Problems with the Evaluation of the CEMEX Model

In investigating the DEIR evaluation of the CEMEX model, I have found some serious problems. Appendix E-2 shows a graph (attached) of observed and model-predicted measurements of groundwater elevations at different sites and times. To critique the evaluation thoroughly, I would need the Excel spread sheets showing the data and the calculations, which the DEIR does not supply.

Figure 37

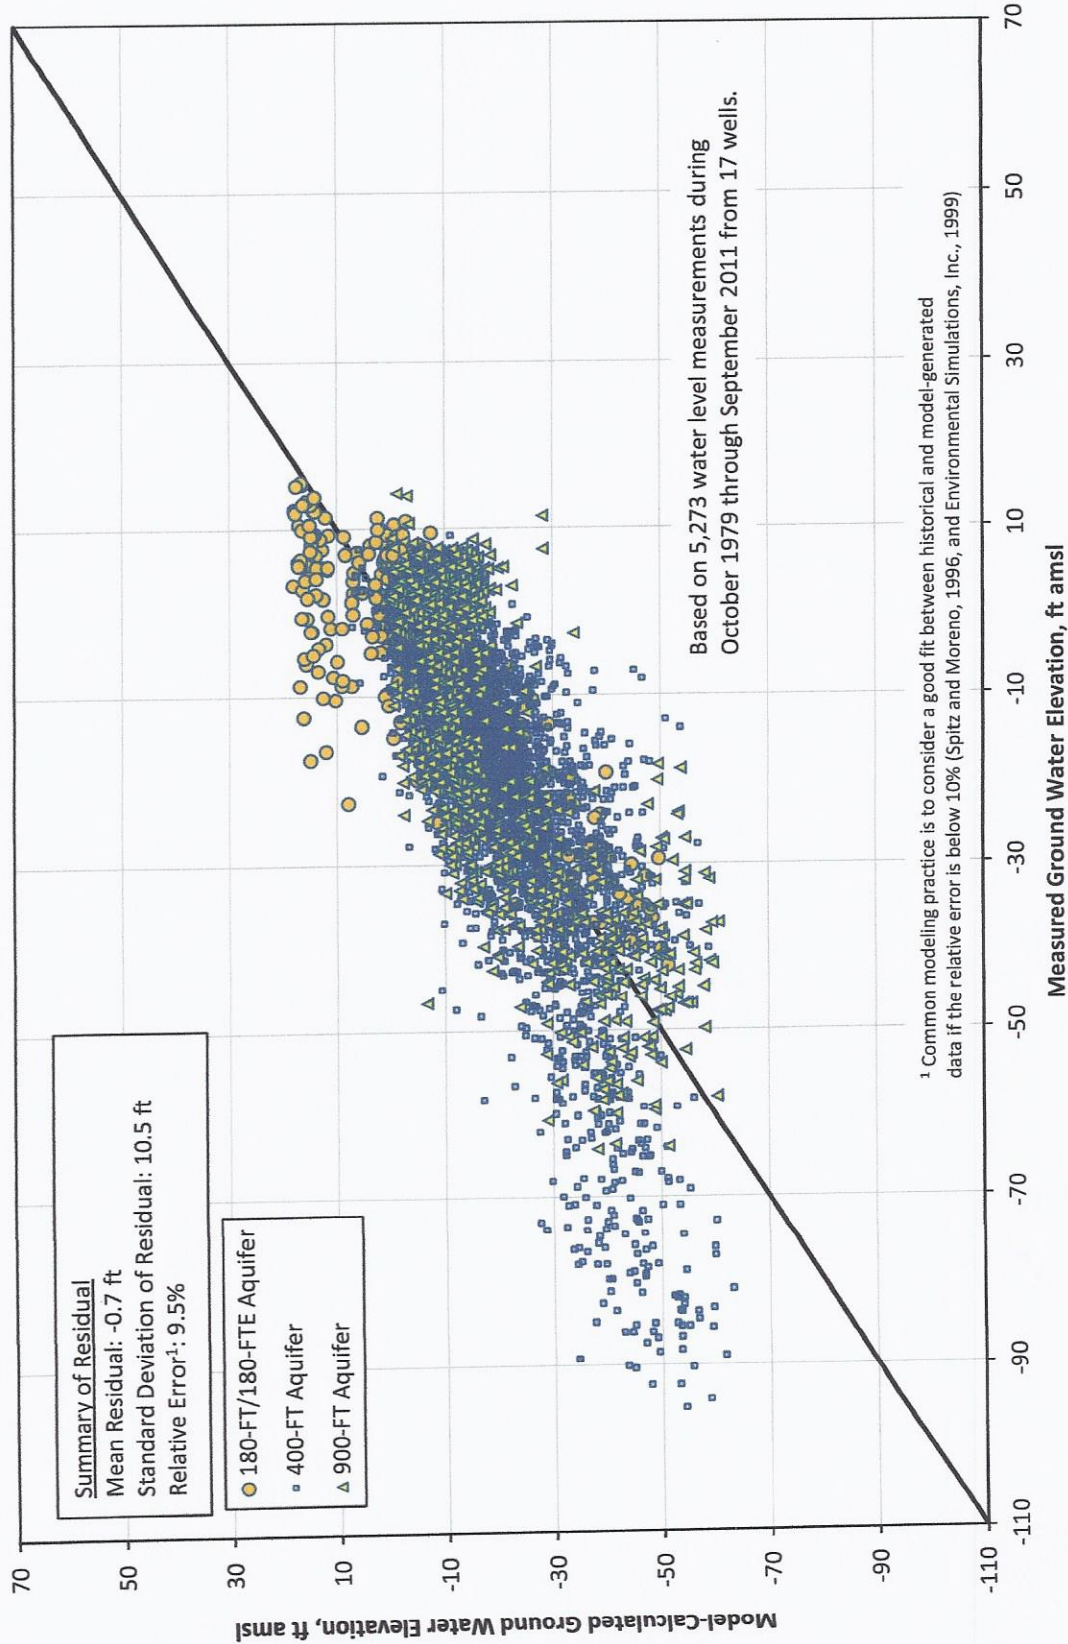
For example, I cannot tell from the graph and its description in the text whether the residuals between predicted and observed measurements were computed by subtracting the first from the second (correct) or the second from the first (incorrect), which Appendix A to Appendix A of Appendix E-2 indicates is being done. Supporting the belief that the determination of residuals might be incorrect is the mean residual reported on the graph. It is -0.7 feet when it should be zero if the residuals had been determined correctly. As presented, the graph shows the estimation of predicted from observed measurements when a prediction line having equal predicted and observed measurements at the two extremes would be correct only if the estimation were in the opposite direction, unless the prediction were perfect (all the points falling on the line).

If you look at the graph, the difference between these two methods of residual computation for each data point is the identification of its residual as the horizontal distance (correct) or the vertical distance (incorrect) between the point and the diagonal line running through the dots from lower left to upper right.

Doing the calculation incorrectly could give a substantially better, but incorrect, evaluation of model fit. I would need the Excel spread sheet showing the data and the calculations to determine which way the residuals were determined and, if determined incorrectly, what the correct model evaluation might be.

Another serious problem with model evaluation is that the data points in the graph represent an area far more extensive than the CEMEX site to which the model is applied, as well as depths not accessed by the slant well there. The depths represented include not only the 180-foot aquifer, which the slant well accesses, but also the 400- and

900-foot aquifers, which the slant well does not access. In fact, the graph shows no data points representing the Dune Sand aquifer, even though it is accessed by the slant well. To provide a truly apt model evaluation, I would need the Excel spread sheet to evaluate the model separately for the 180-foot aquifer. Examination of the graph suggests that the fit for these data points (yellow-filled circles) may not be very good at all, many of the predicted elevations being uniformly much too high.

Since the slant well draws water only from the Dune Sand and 180-foot aquifers, a graph and residual calculations should be based on data from only these depths within the CEMEX area.

REPORTING REMEDIATION. The EIR should report the correlation coefficient between observed and predicted values for both the entire data set and for the data set restricted to the CEMEX area and the 180-foot aquifer. This statistic does not depend on the method of residual determination. One minus its square is the proportion of observed measurement variation that is not predicted, or is unaccounted for, by the model. This proportion is the statistical standard of model evaluation.

OPERATIONAL REMEDIATION. Since the model is unevaluated for one portion of its intake source region (Dune Sand aquifer) and is inadequately and likely erroneously evaluated for the other (180-foot aquifer) at the CEMEX site, reliance on the model to make predictions of the impact of slant-well pumping on groundwater elevations is out of the question for any envisioned scenario. Data collection over dozens of months of test-well pumping is necessary to evaluate the effects of the proposed project on groundwater elevations before a decision can responsibly be made to go forward with the project. Without such data collection, no EIR would be adequate and no CPCN could be justified.
